City of Sandy

Planning Commission Meeting

**Meeting Date: Monday, August 24,
2020**

- 8.1. 19-050 CPA ZC SUB SAP TREE Bull Run Terrace 88 - 614
[19-050 CPA ZC SUB SAP TREE Bull Run Terrace - Pdf](#)
[Letter from Tracy Brown \(received August 20, 2020\)](#)
[Fair Housing Council of Oregon \(August 24, 2020\)](#)
[ODOT comments \(August 24, 2020\)](#)
[Public Comments \(August 14 - August 24 through 3 PM\)](#)

HIGHWAY 26 - HIGHWAY
NTS

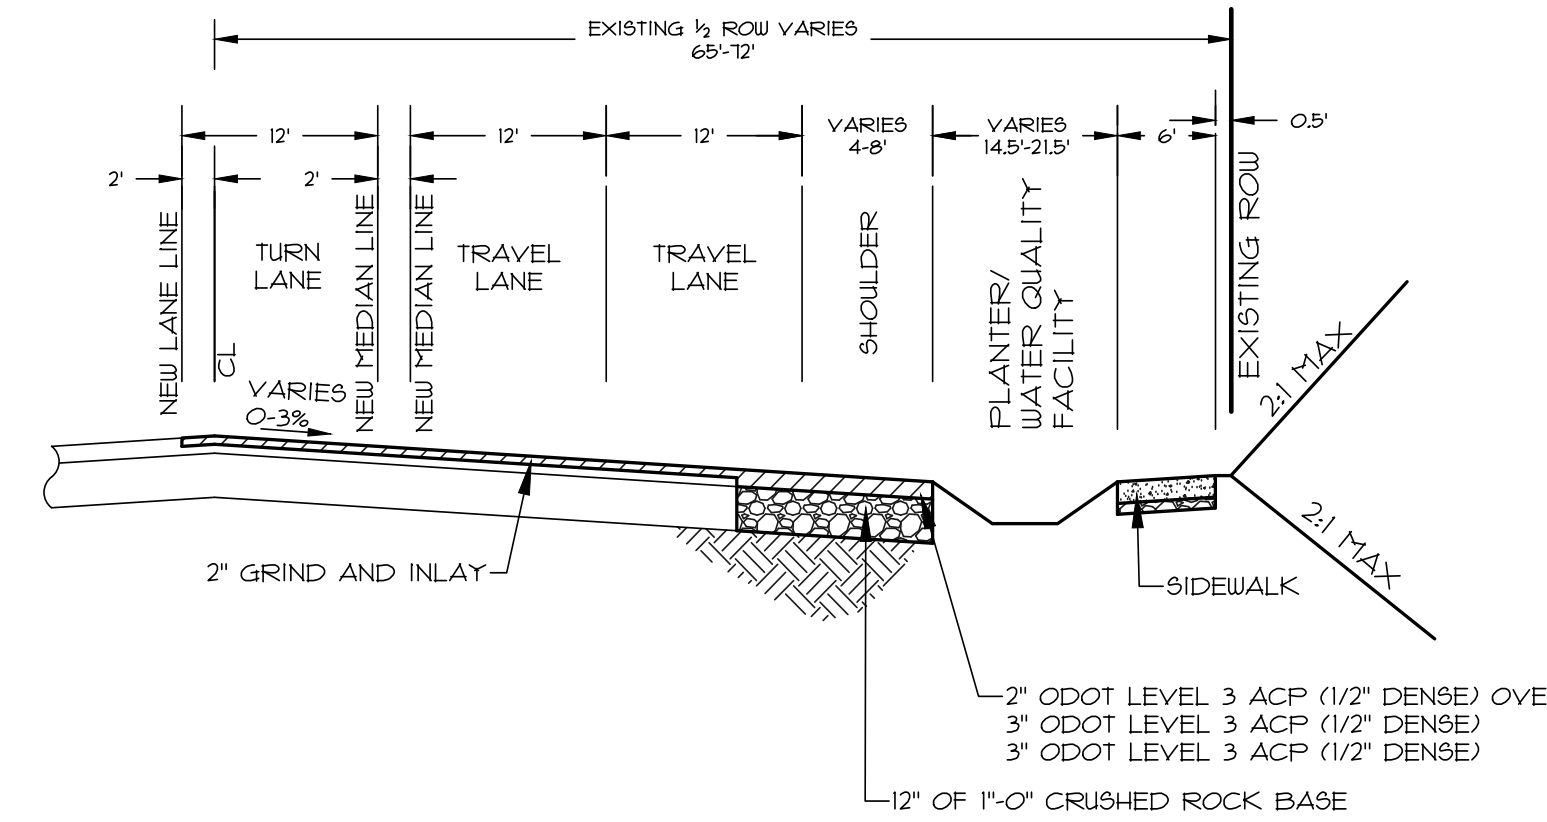
74. Section 17.84.60 outlines the requirements of public facility extensions. The applicant submitted a utility plan (Exhibit C, Sheet 5) which shows the location of proposed public water, sanitary sewer, and stormwater drainage facilities. Broadband fiber service will be detailed with construction plans. A private sanitary sewer connection is proposed to serve Lot 7. All other utilities will be public.

- f) **Detail the alignment of the intersection of Street B and Dubarko Road to provide the minimum 100 feet of tangent section.**
 - g) **Detail a 40 foot by 40 foot right-of-way dedication or permanent traffic signal easement at the northeast corner of Lot 7 to accommodate a future traffic signal.**

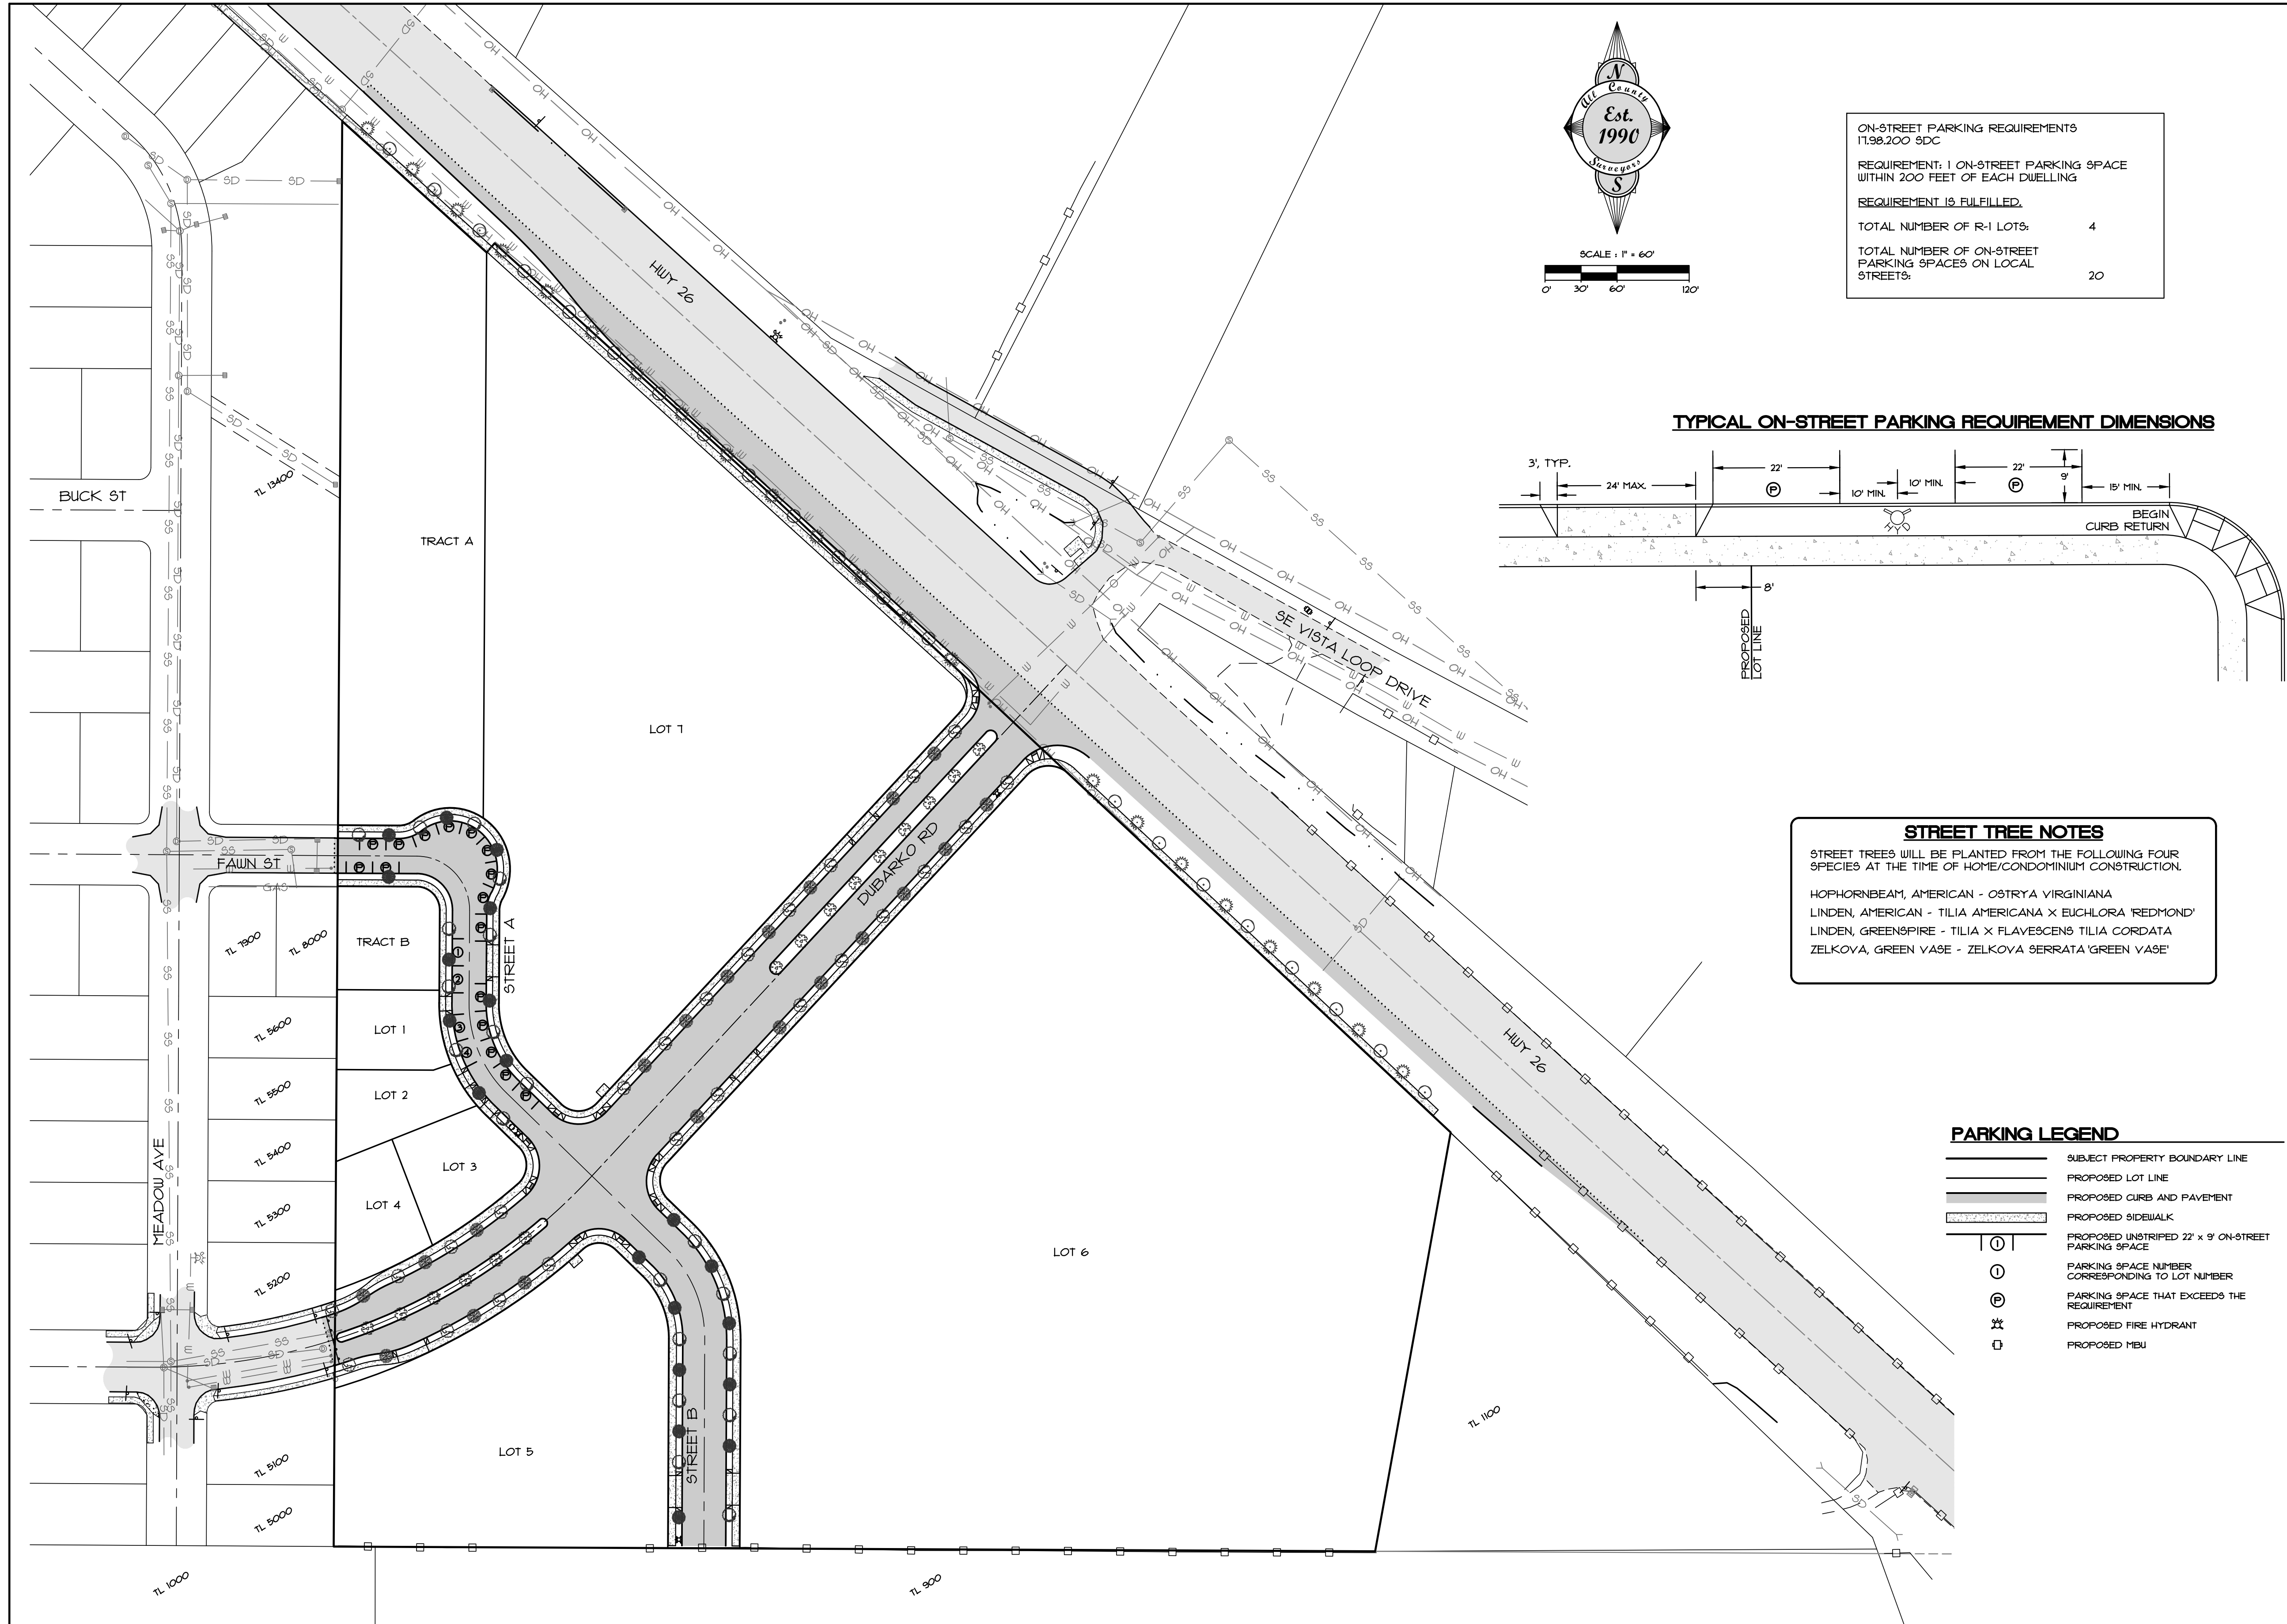
89. Section 17.92.30 specifies that street trees shall be chosen from the City-approved list. As required by Section 17.92.30, the development of the subdivision requires medium trees spaced 30 feet on center along all street frontages. The current street tree plan (Exhibit D, Sheet 7) does not show the distance between trees. **The applicant shall update the Street Tree Plan to show the distance between trees, and this distance shall be 30 feet on center.**

94. Section 17.98.10(M) requires that the developer provide a Residential Parking Analysis Plan. This plan identifying the location of parking for the four R-1 zoned lots and is included in Exhibit C, Sheet 7.
